## Main Modification 20 - Index by ID Number

## Site Allocations DPD: Main Modifications Response

DM/20/4692  
Land behind St Stephen's Church,  
Hamsland, Horsted Keynes

Review of Swept Path Analyses and Landholding – Rev 2

# Original Swept Path Analysis: Rev A, Apr 19

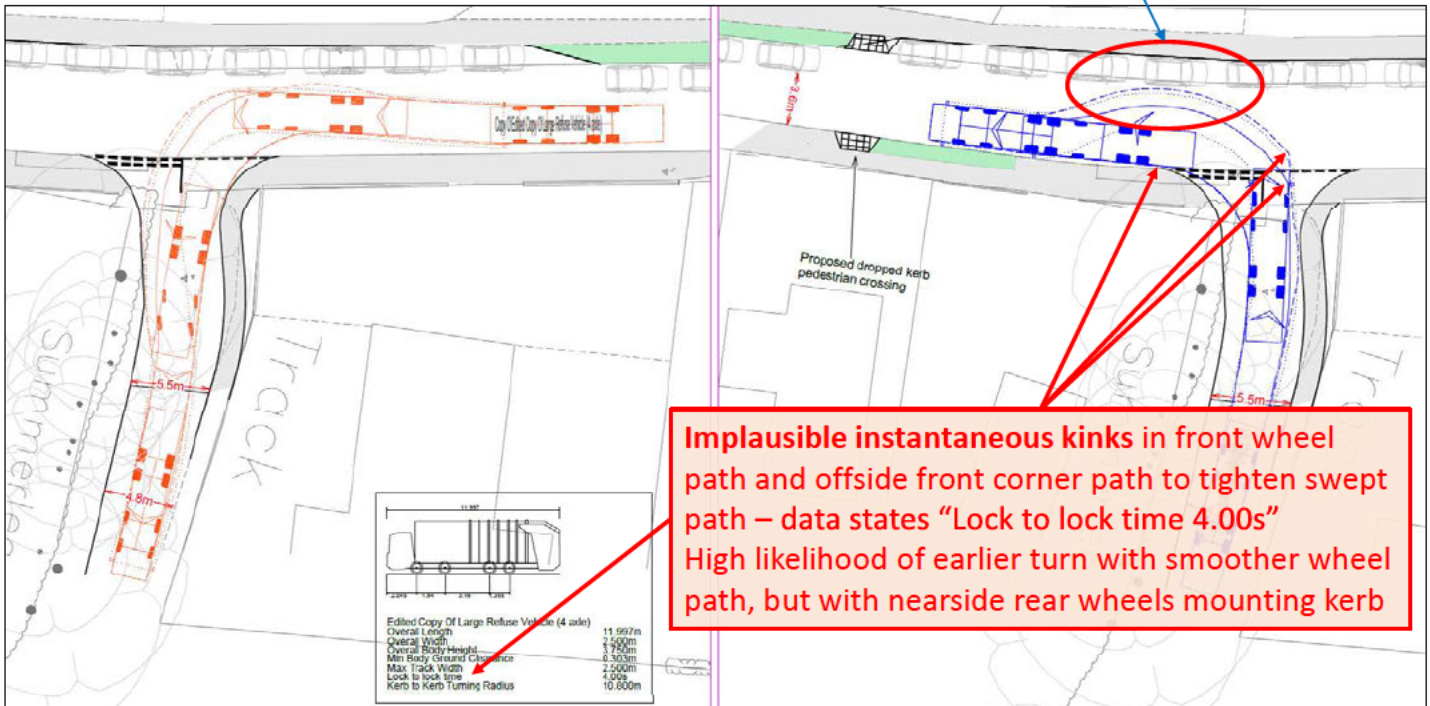
Only two of four manoeuvres shown in Transport Statement. Onerous right turn out not shown

Tight but appears to just fit within assumed 5.7m clear road width, albeit see caveat in box below

Implausible instantaneous kinks in front wheel path and offside front corner path to tighten swept path – data states “Lock to lock time 4.00s”  
High likelihood of earlier turn with smoother wheel path, but with nearside rear wheels mounting kerb

# Rev D Swept Path Detail: Right Turn Out

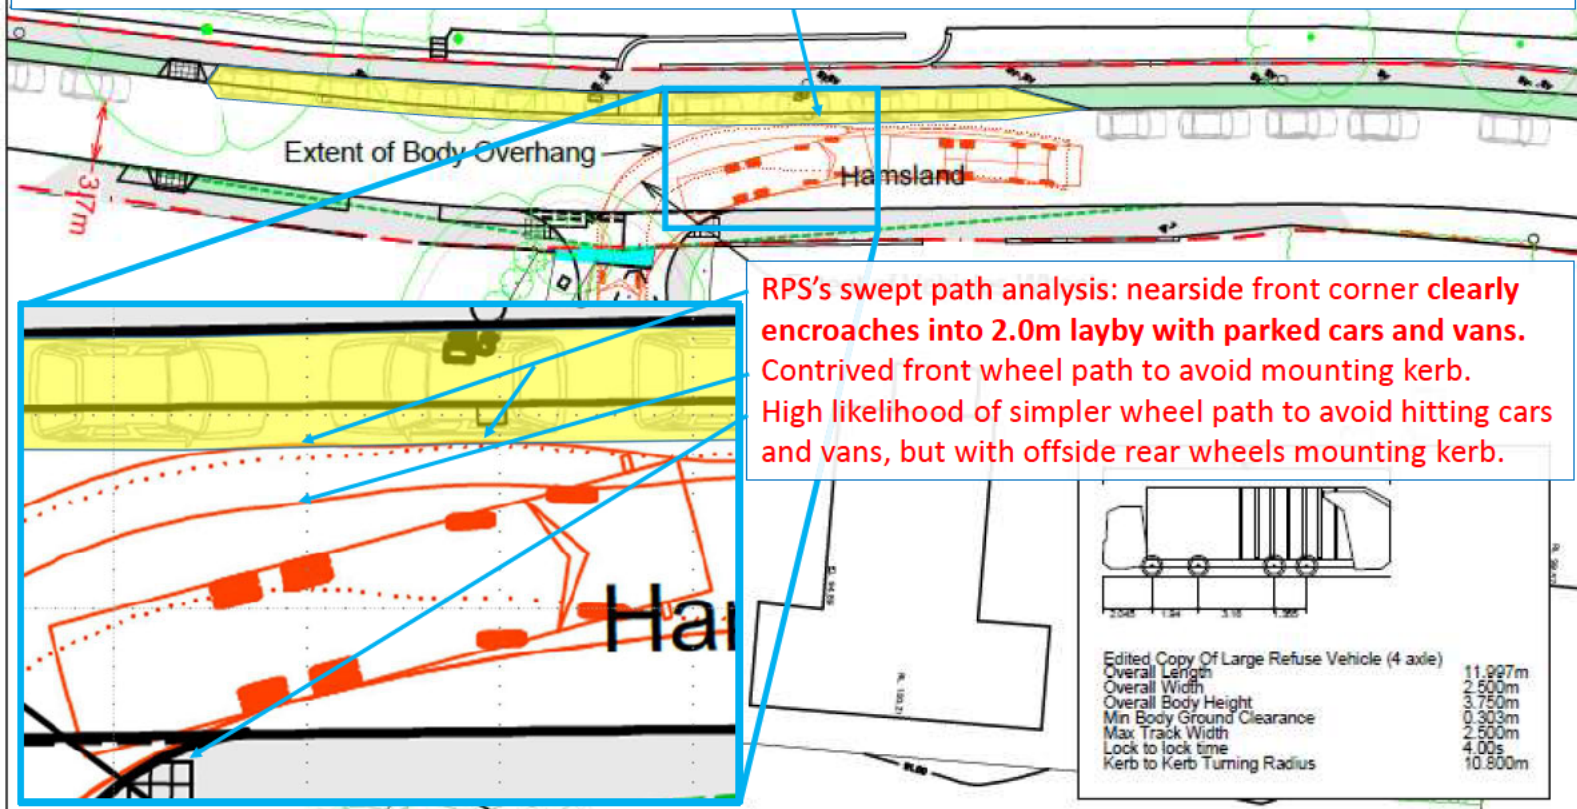
Yellow tone shows MfS 2.0m layby zone - wing mirrors of parked cars can be anywhere within this zone.  
*Note: several residents here own wider work/camper vans which for many years have been parked in this area*

# Rev D Swept Path Detail: Left Turn Out

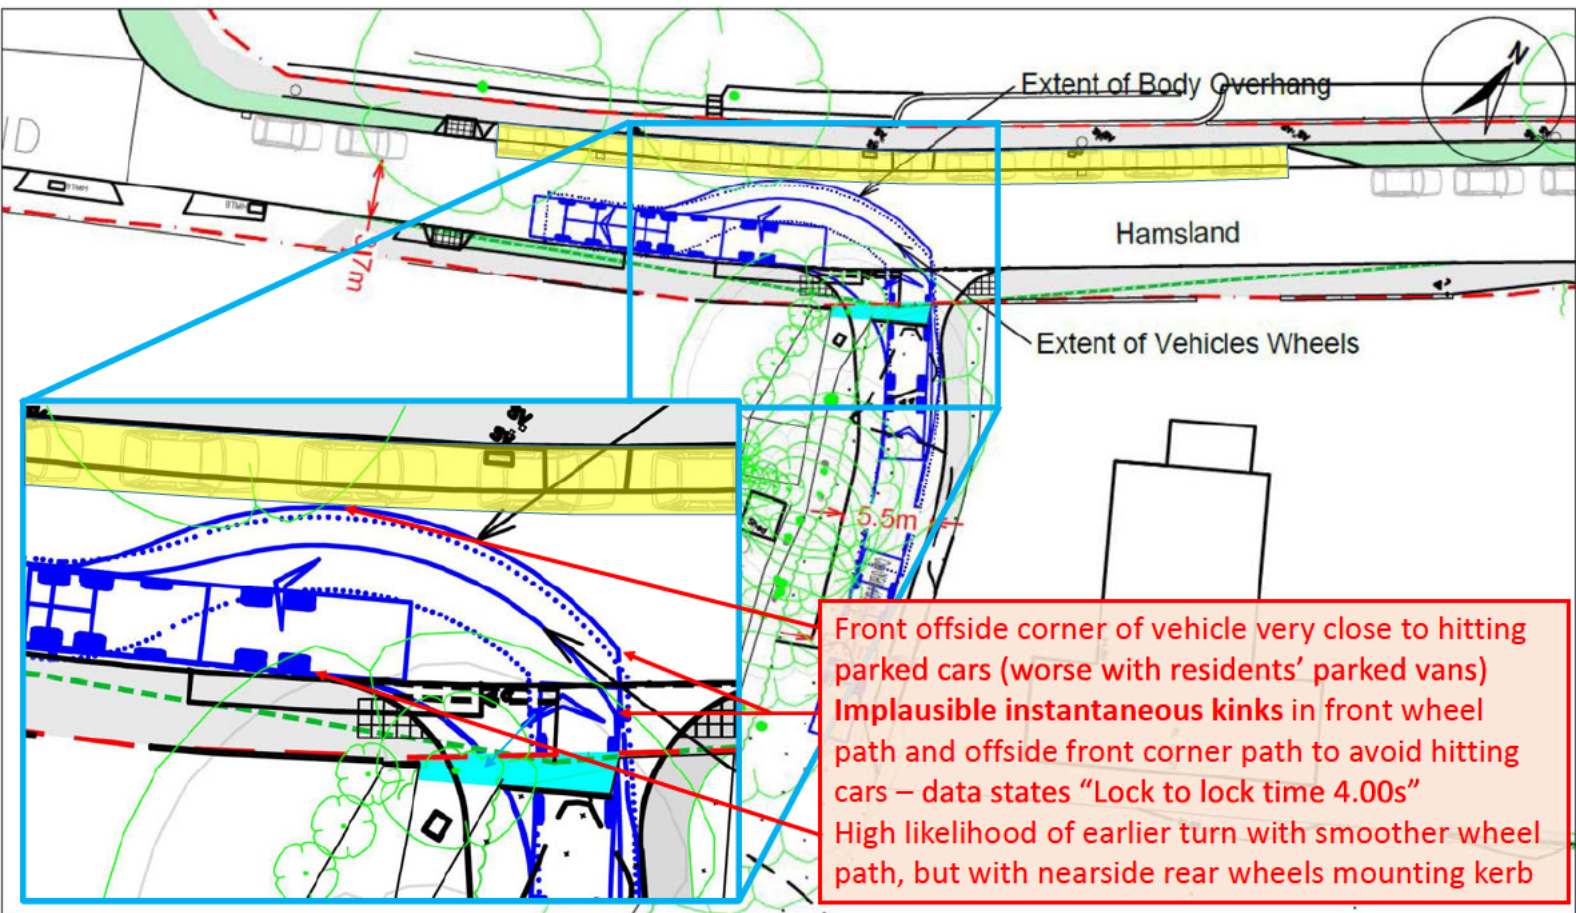
- With reduced road width of 5.4m, the swept paths *do not work* for left hand and right hand turn out of site by reference waste collection vehicle.
- High likelihood that *parked cars and vans will be struck* and/or that rear wheels of the waste collection vehicle *will track up* onto the inner pavement.
- This does not comply with more robust draft policy SA29:

# Planning Application 'Latest Plan'

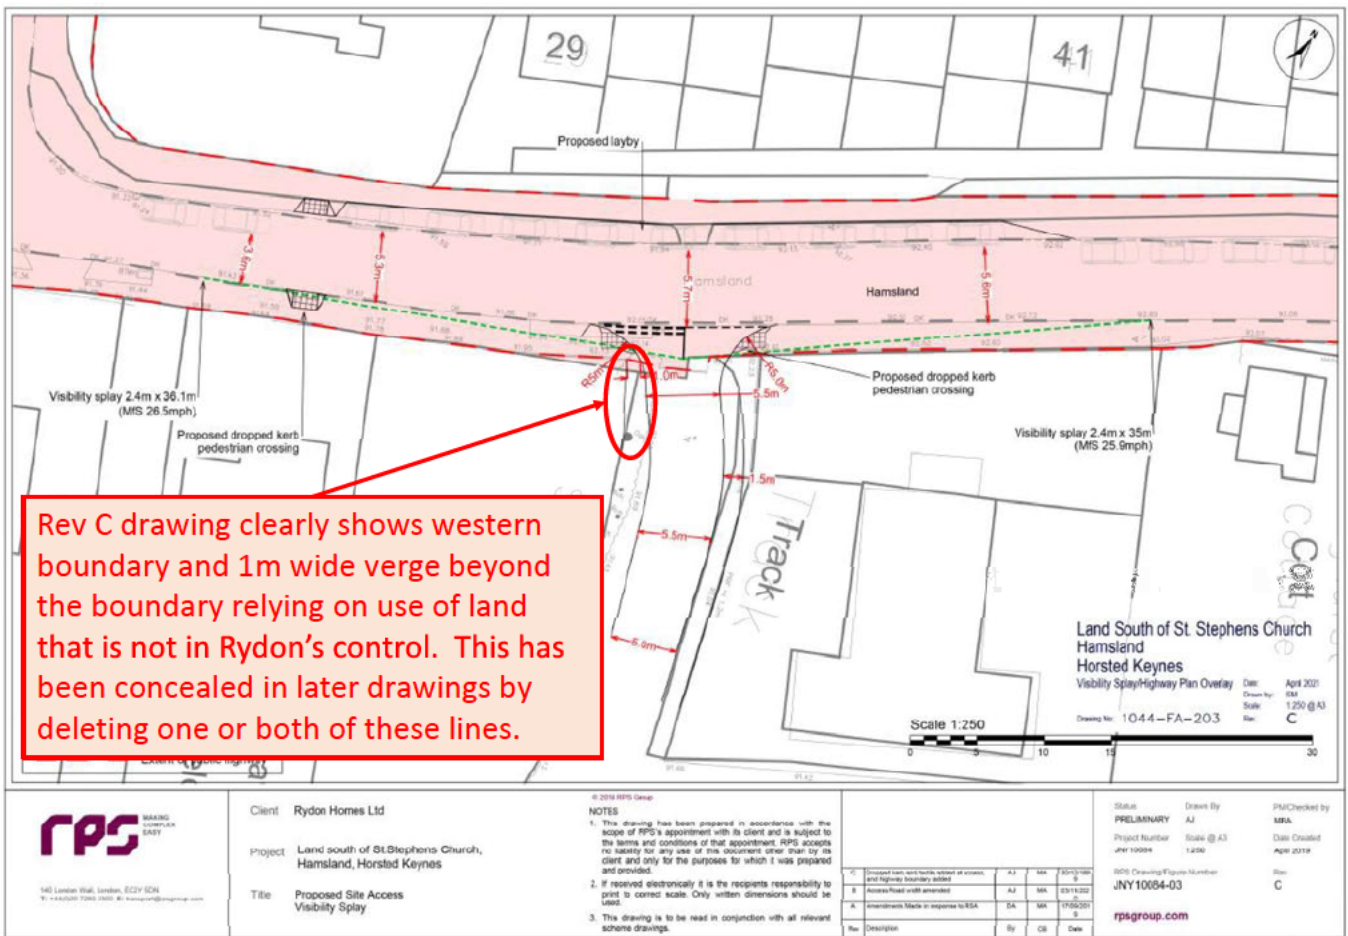
Rev C drawing clearly shows western boundary and 1m wide verge beyond the boundary relying on use of land that is not in Rydon's control. This has been concealed in later drawings by deleting one or both of these lines.

# WSCC Highways Landholding Concern

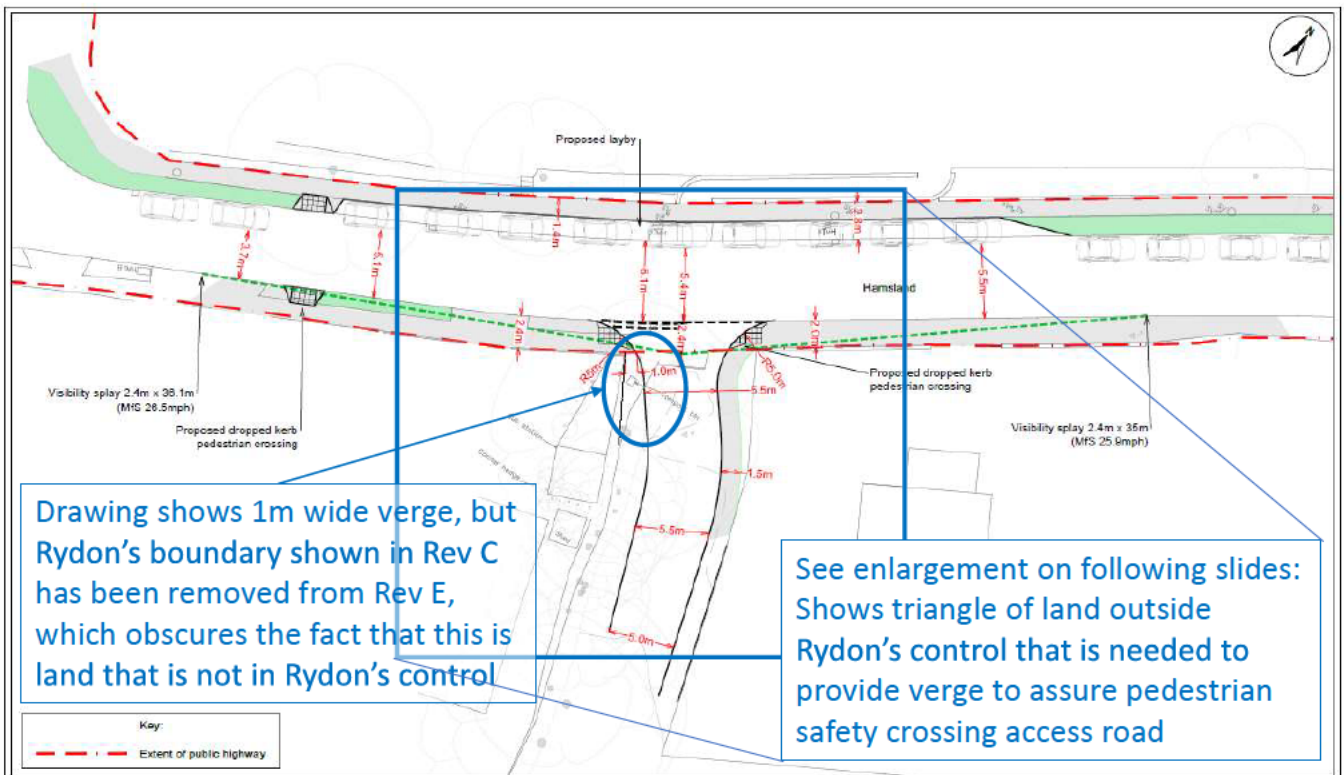
“Regards the highway boundary I understand this has been slightly amended by our land charges dept. to reflect the width of footway on the ground. The red edge previously provided is therefore incorrect as there appears to be a small section that is in third party land. *If the applicant does have rights over this it needs to be indicated on the plans to provide the access and splays.* If the splays can be provided in highway boundary only this needs to be clearly shown but the full width of access route will still be needed to provide the access/road to site. We would likely take 2m ‘X’ distance for visibility splays here but the red edge still needs addressing to be able to provide the access.”

“The amended plan now shows tactile/dropped kerb point across site access. As per email comments sent to the Local Planning Authority on 14 June 2021, the red line edge of site should be amended following updated highway boundary information. *It should be demonstrated that the proposed access and visibility splays can be delivered without third party land.*”

# Extract: Site Access Layout: Rev E, Aug 2021

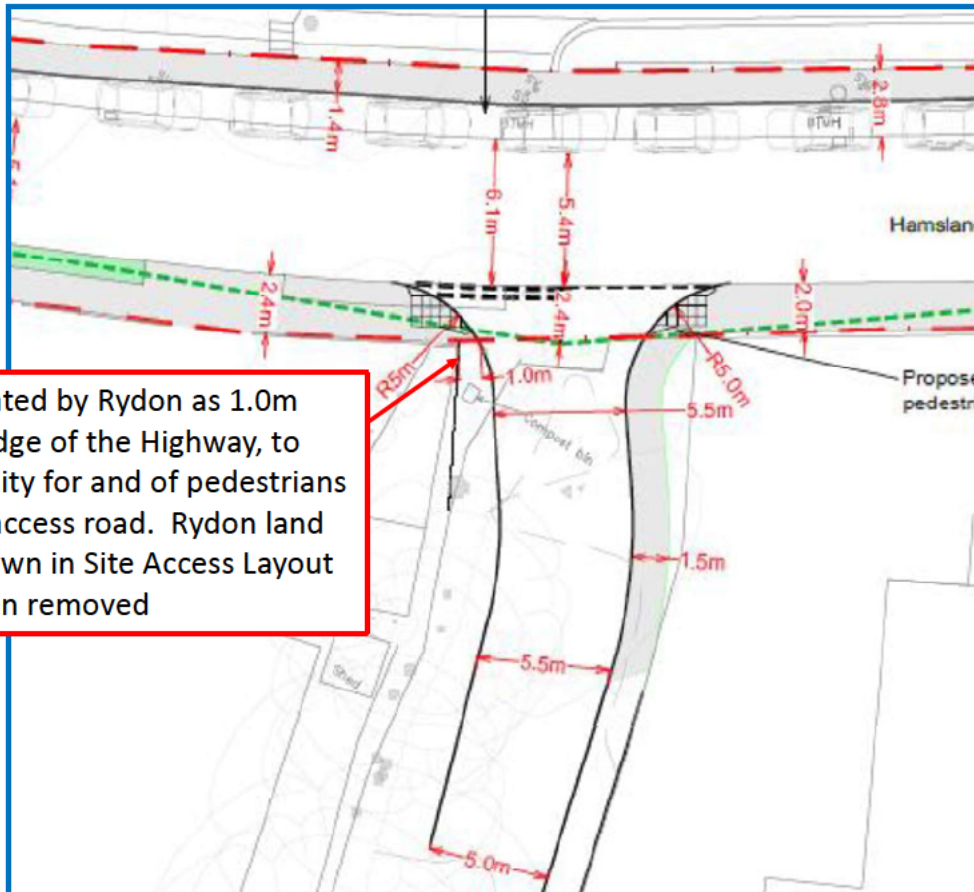
Verge, annotated by Rydon as 1.0m wide at the edge of the Highway, to provide visibility for and of pedestrians crossing site access road. Rydon land boundary shown in Site Access Layout Rev C has been removed

# Extract: Composite Access Drawing, Nov 21

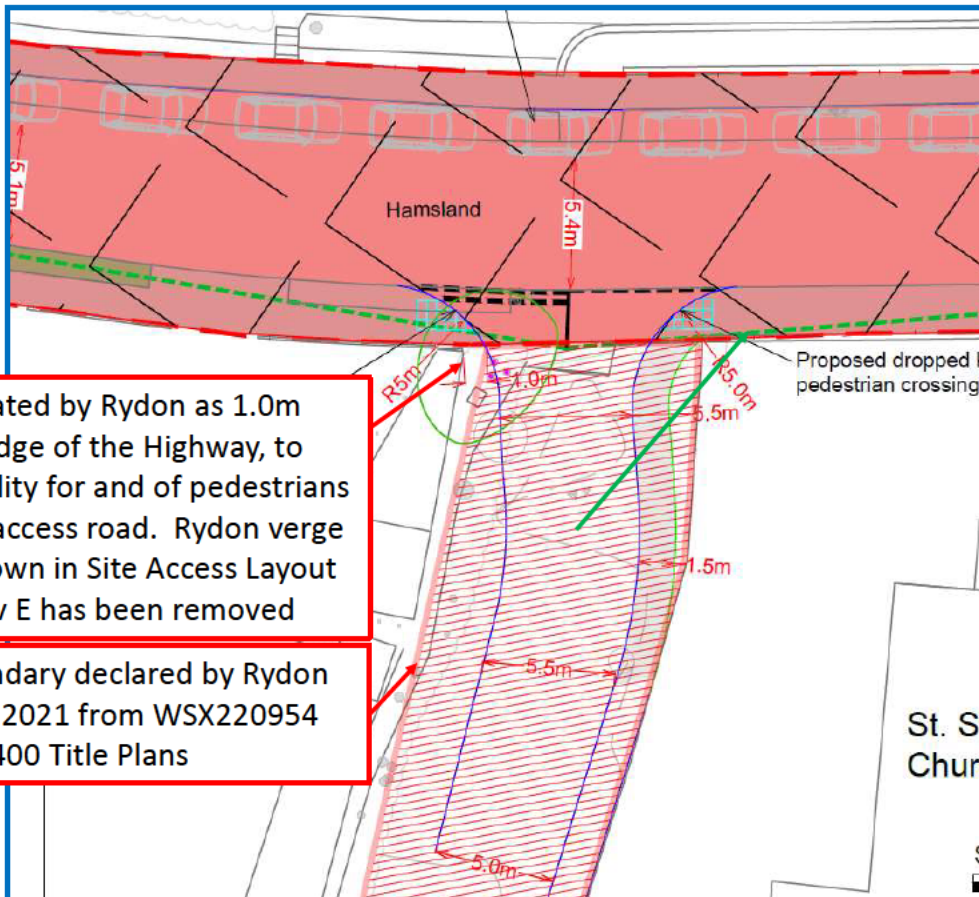
Verge, annotated by Rydon as 1.0m wide at the edge of the Highway, to provide visibility for and of pedestrians crossing site access road. Rydon verge boundary shown in Site Access Layout Rev C and Rev E has been removed

# Extract: Composite Access Drawing, Nov 21

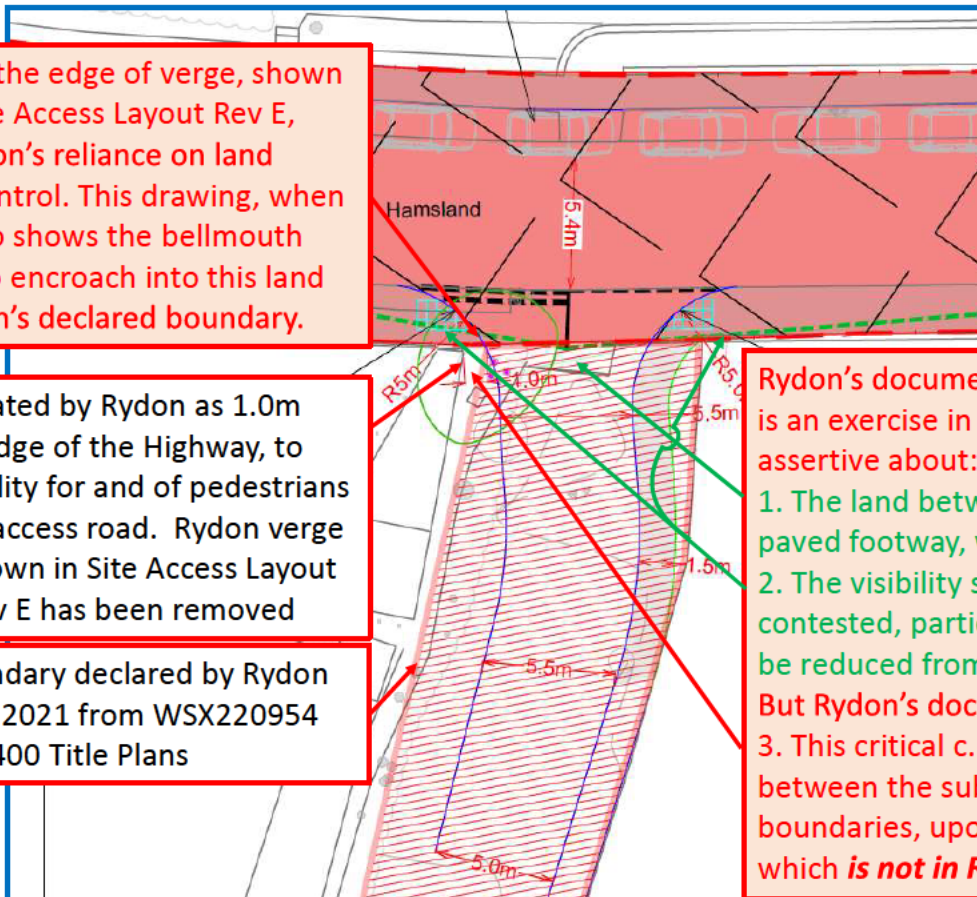
Not showing the edge of verge, shown clearly on Site Access Layout Rev E, conceals Rydon's reliance on land outside its control. This drawing, when enlarged, also shows the bellmouth kerb may also encroach into this land beyond Rydon's declared boundary.

Rydon's document including this drawing is an exercise in deflection. It is boldly assertive about:

1. The land between the gate and back of paved footway, which is not contested
2. The visibility splays, which are not contested, particularly as X distance could be reduced from 2.4m to 2.0m if required. But Rydon's document is totally silent on:
3. This critical c. 1.0m wide strip of land between the substation and Rydon boundaries, upon which Rydon relies but which **is not in Rydon's control**

# Extract: Composite Access Drawing, Nov 21

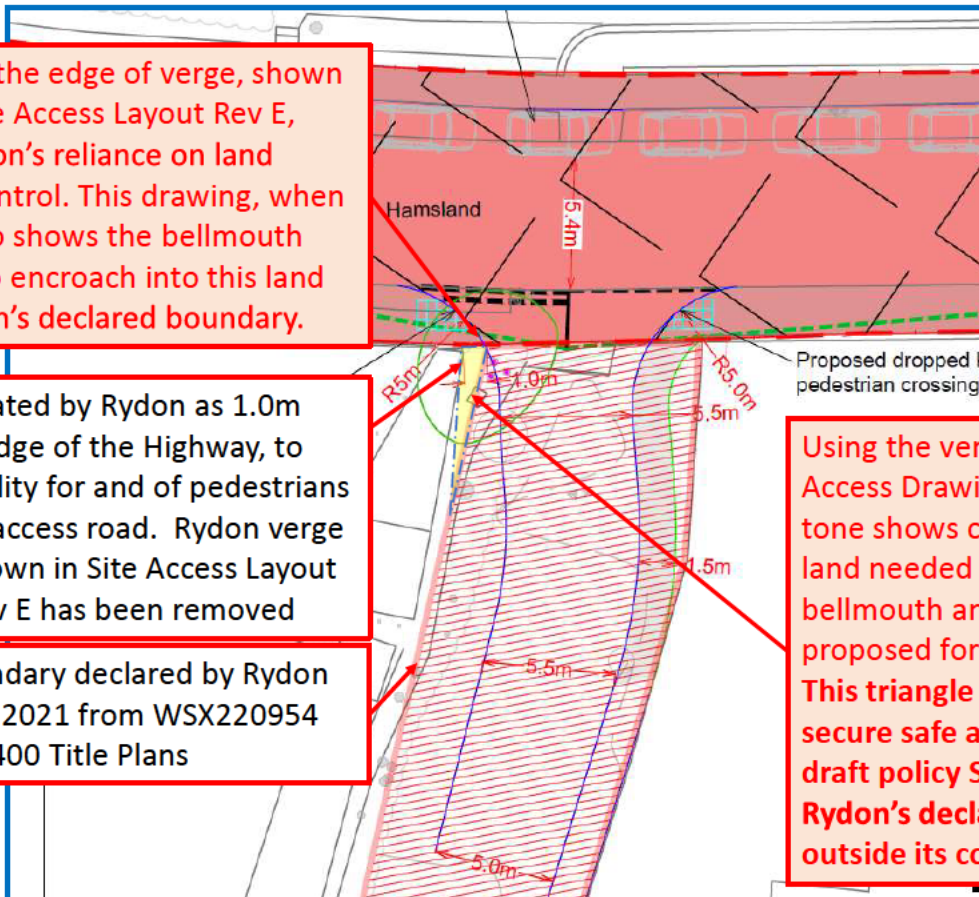
Not showing the edge of verge, shown clearly on Site Access Layout Rev E, conceals Rydon's reliance on land outside its control. This drawing, when enlarged, also shows the bellmouth kerb may also encroach into this land beyond Rydon's declared boundary.

Using the verge boundary on Site Access Drawing Rev E, the yellow tone shows clearly the triangle of land needed by Rydon for the bellmouth and the 1.0m wide verge proposed for pedestrian visibility. This triangle of land is necessary to secure safe access, as required by draft policy SA29, but is beyond Rydon's declared boundary and is outside its control
